# **Electron Hydro Diversion Repair and Spillway Replacement Project Water Quality Monitoring Plan Winter Stabilization Version**

September 19, 2020

## Responses to Corps Questions Re: Plan Submitted August 18, 2020

PIERCE COUNTY Figure 1 WASHINGTON

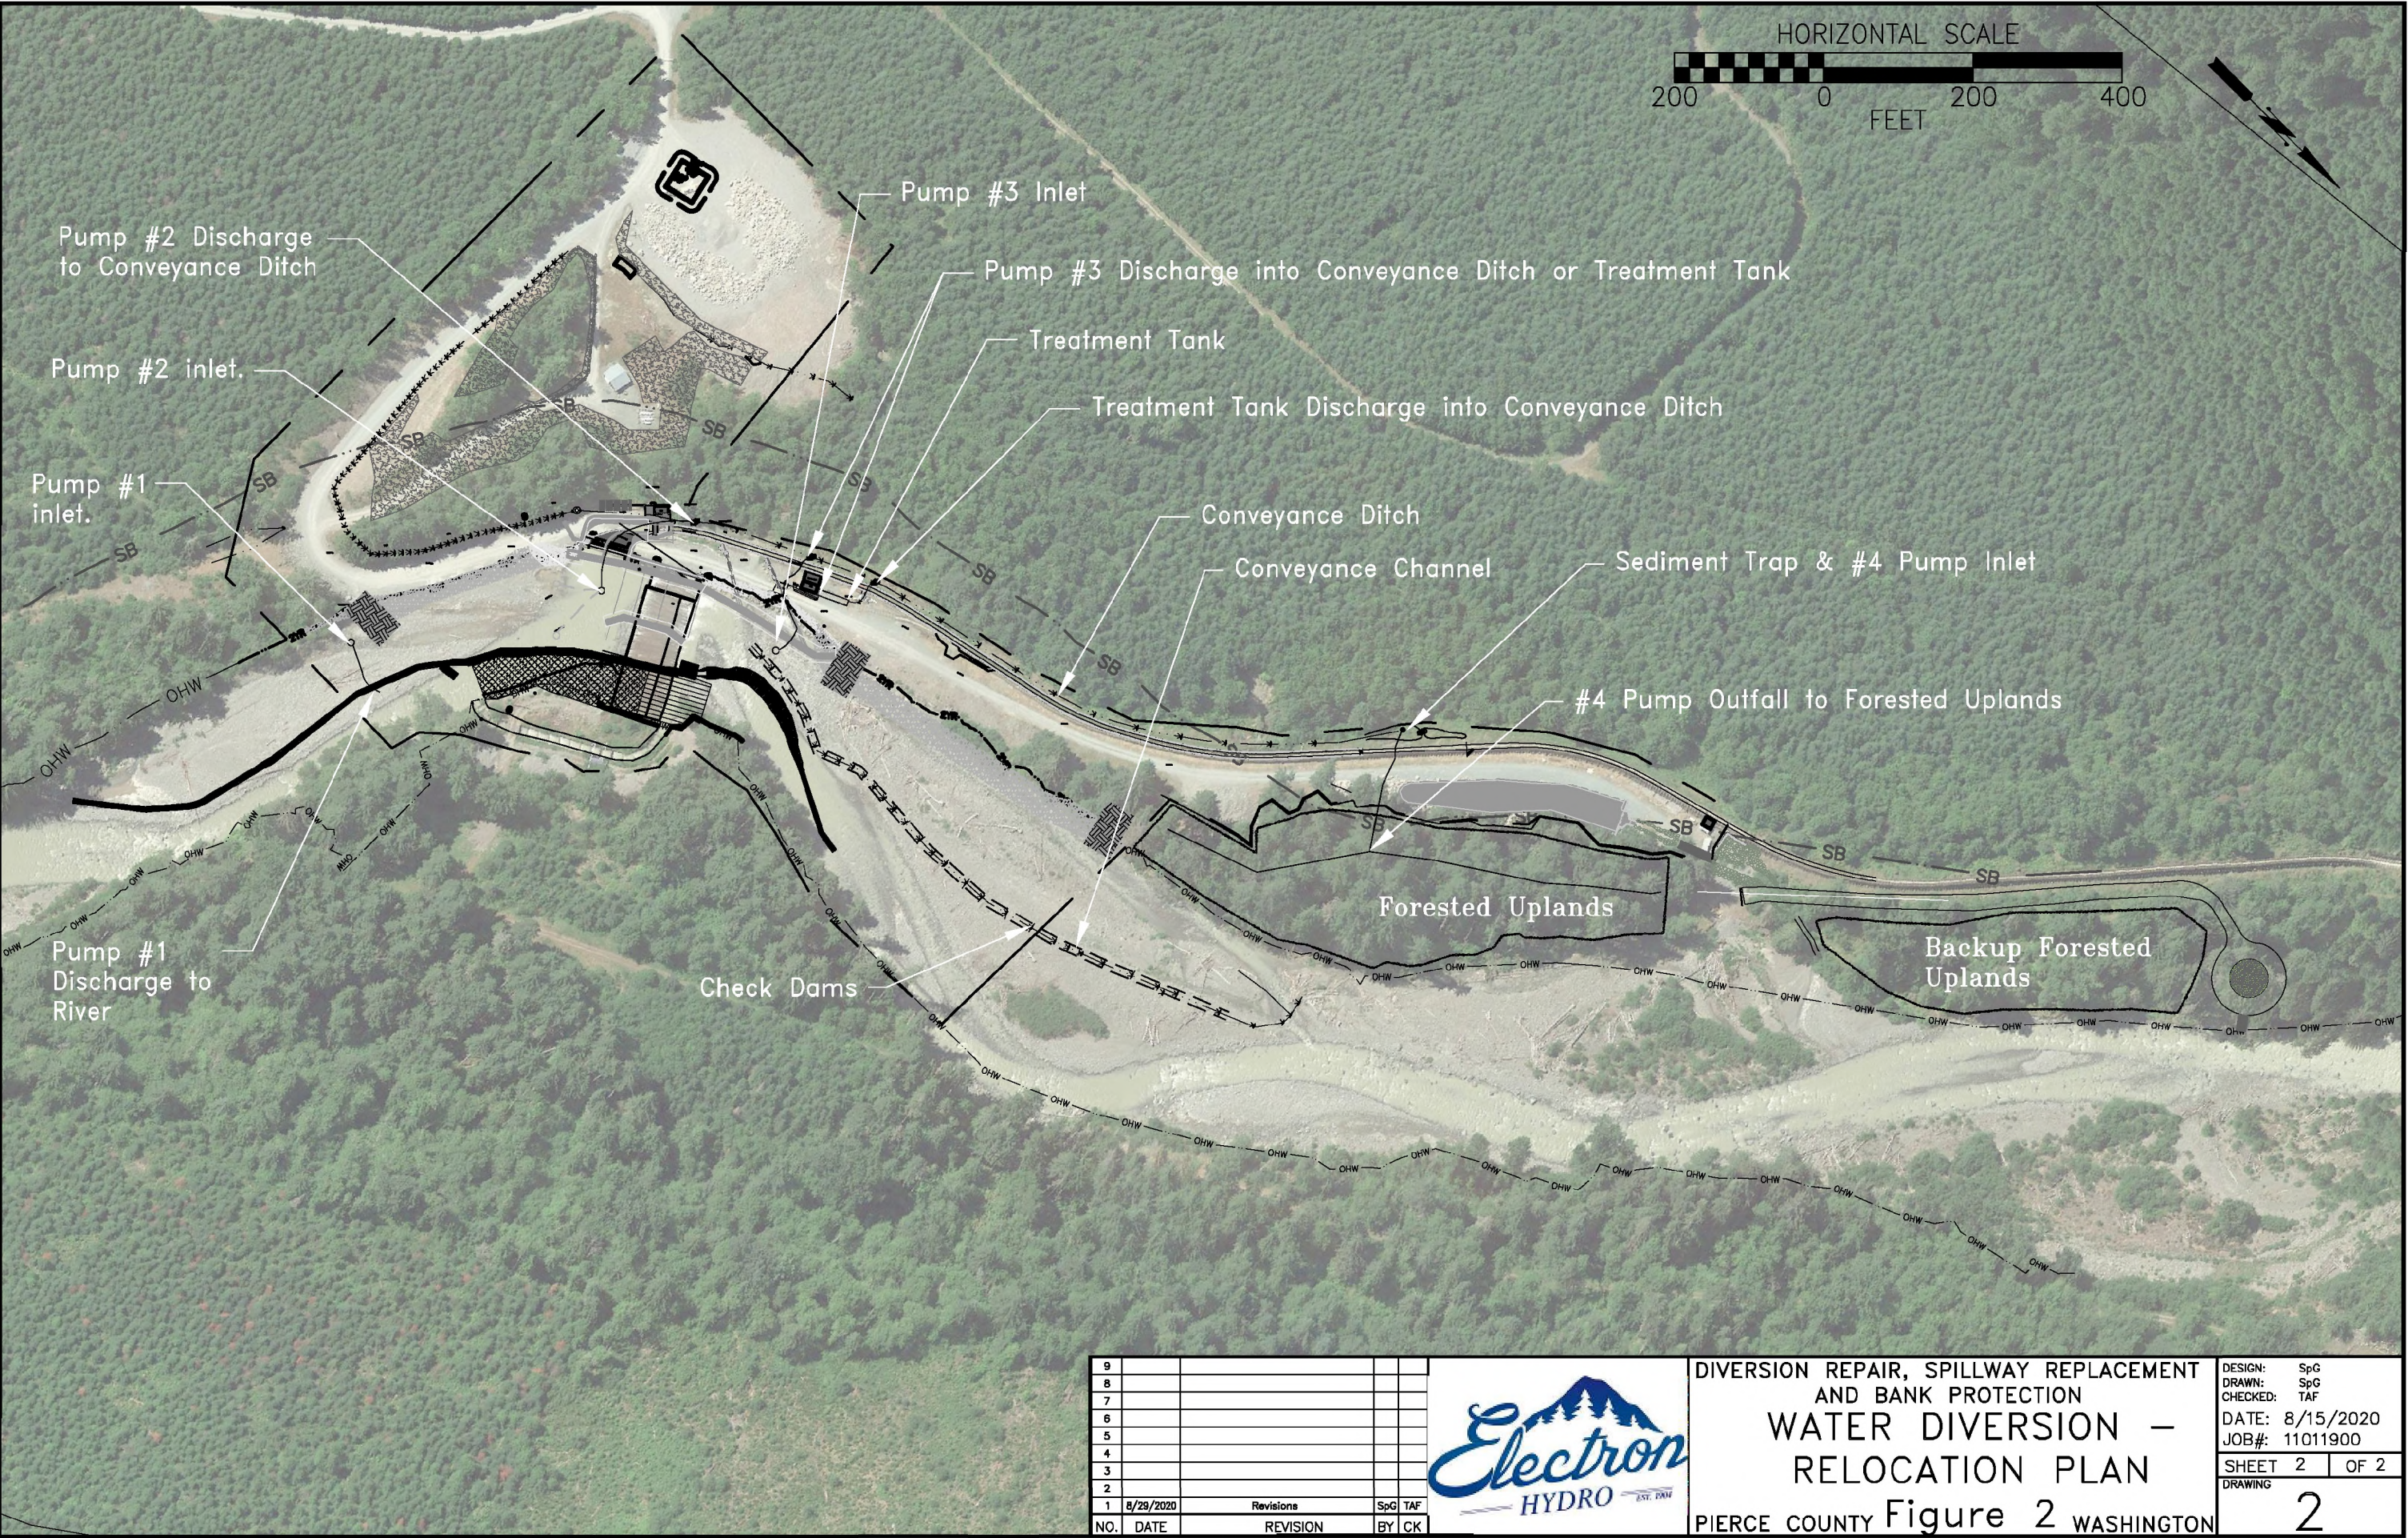
| 2            | 8/26/20 | Figure 1, Page 11 shows new #4 Outfall Sample Point location.   |
| 5            | 8/30/20 | Clarify text and Revised Figure 1 with new note.  |

Figure 2 Page 14 of 16

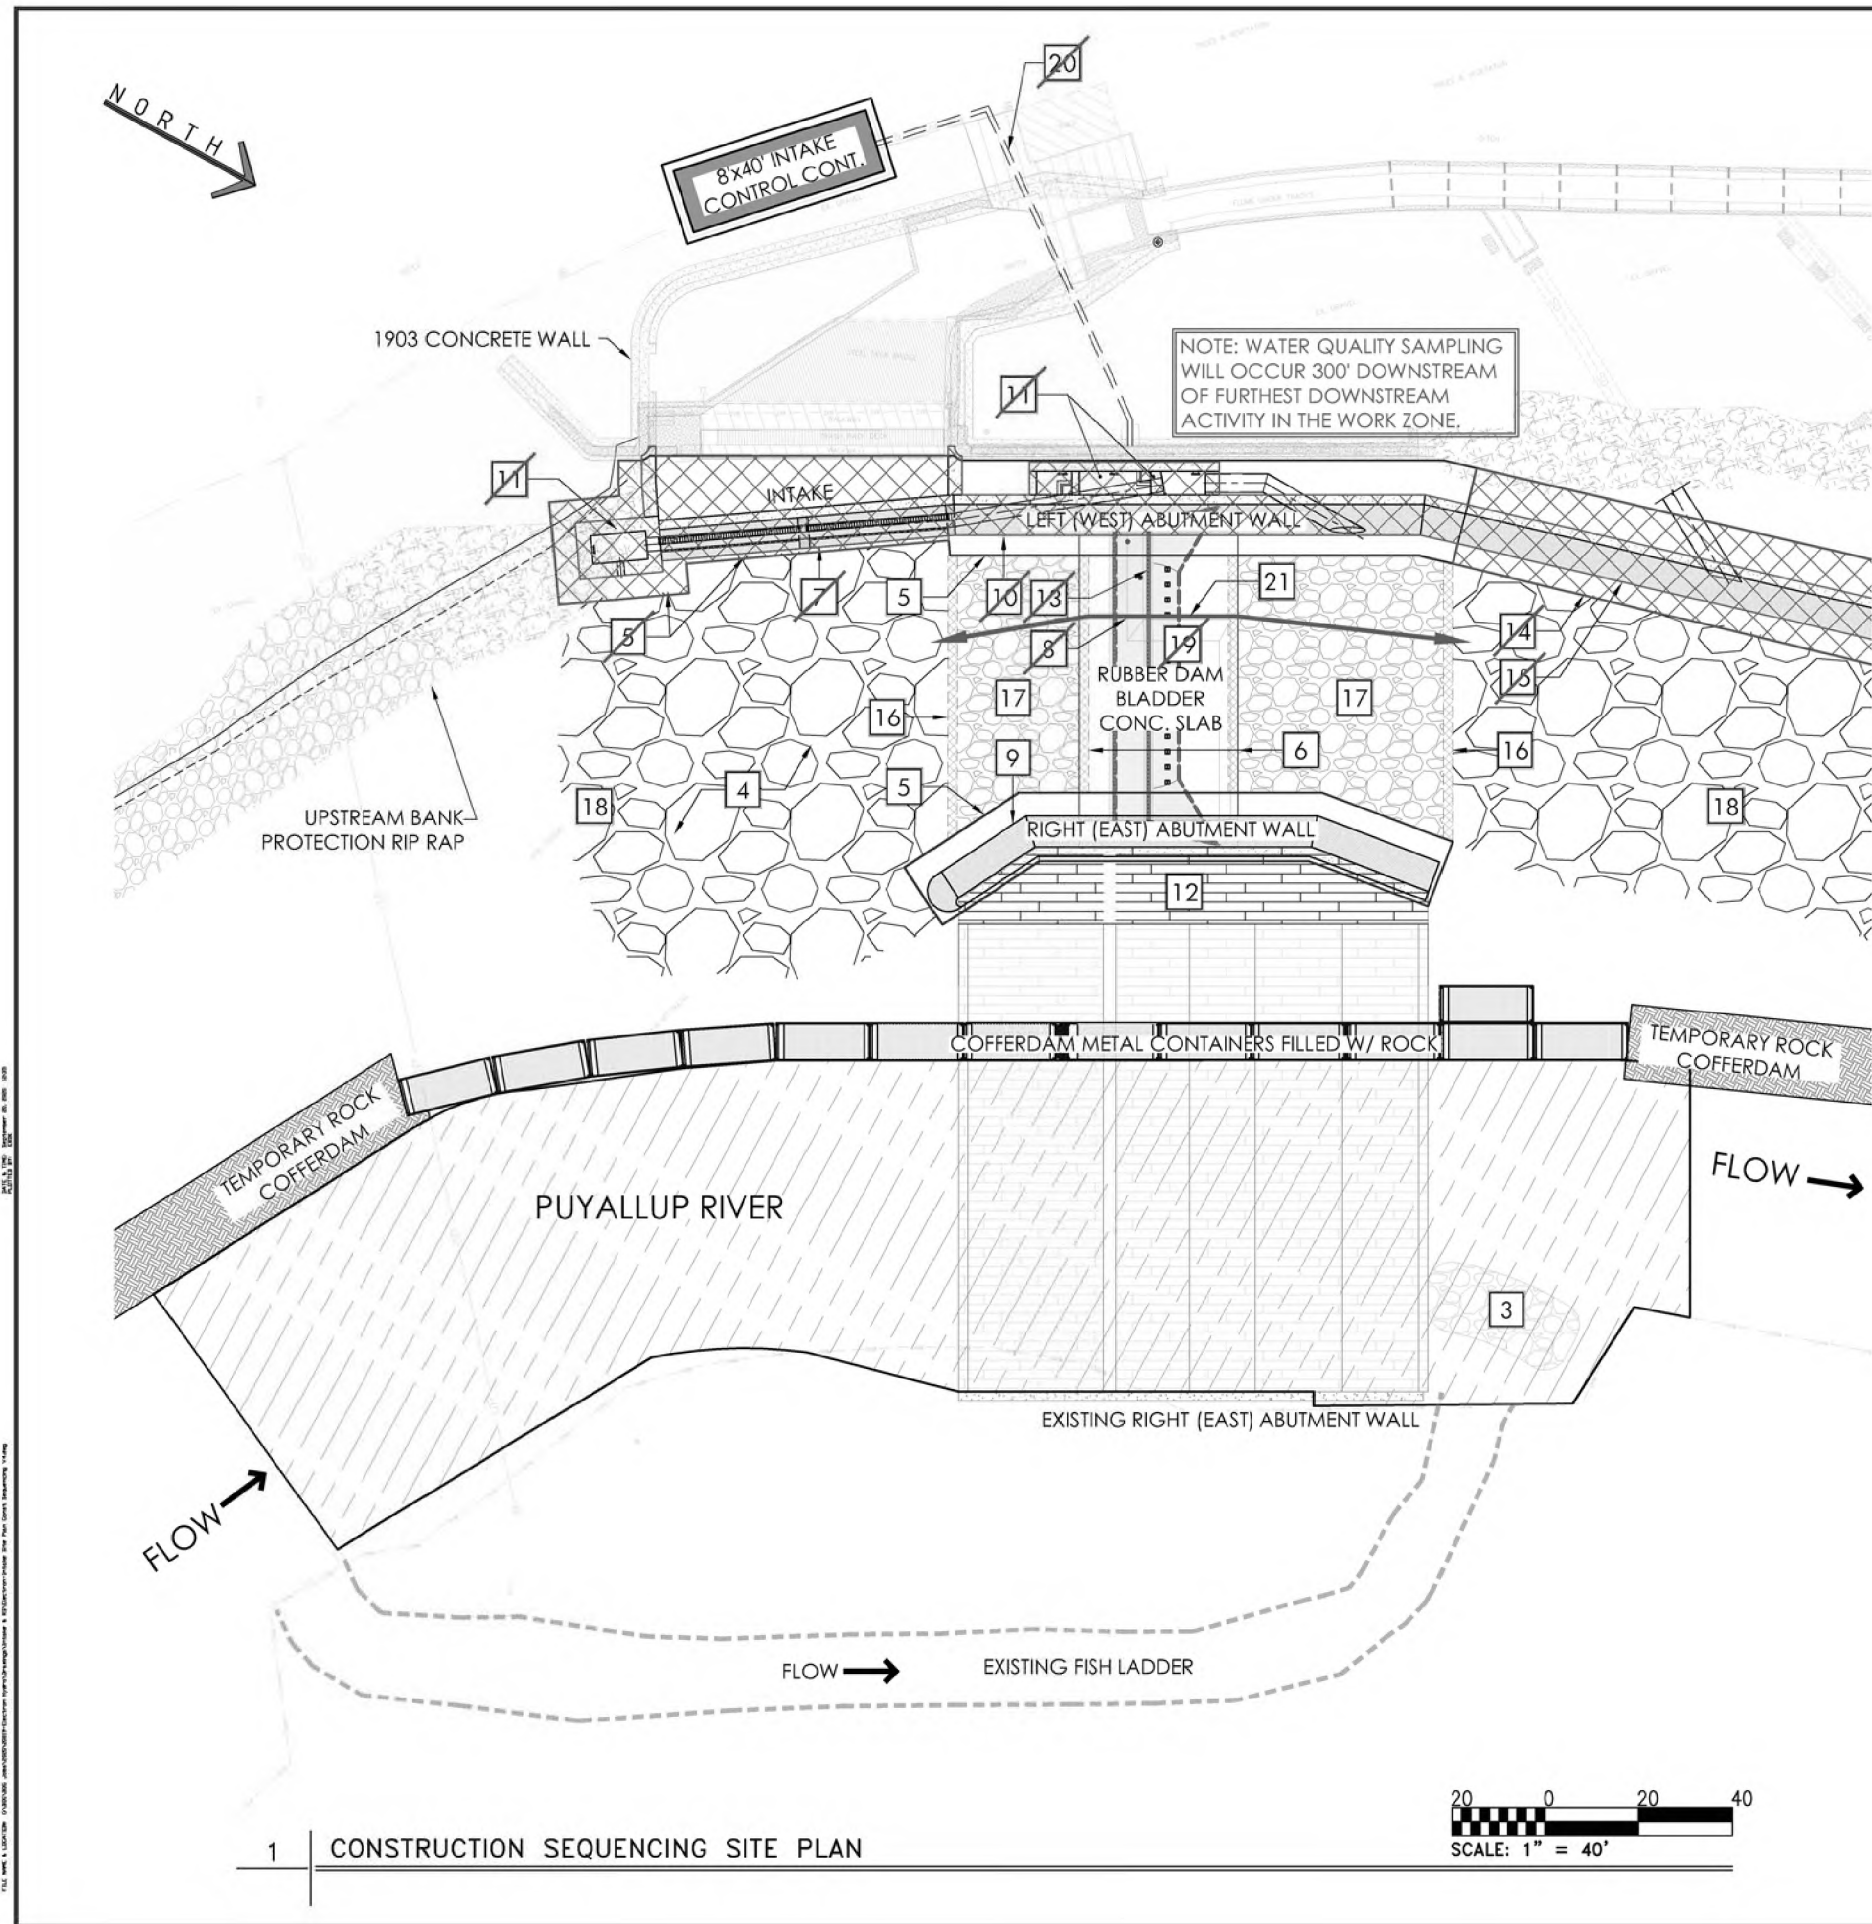
| 3            | 8/27/20 | Figure 2, Page 12 shows check dams at the Outfall Channel.  |
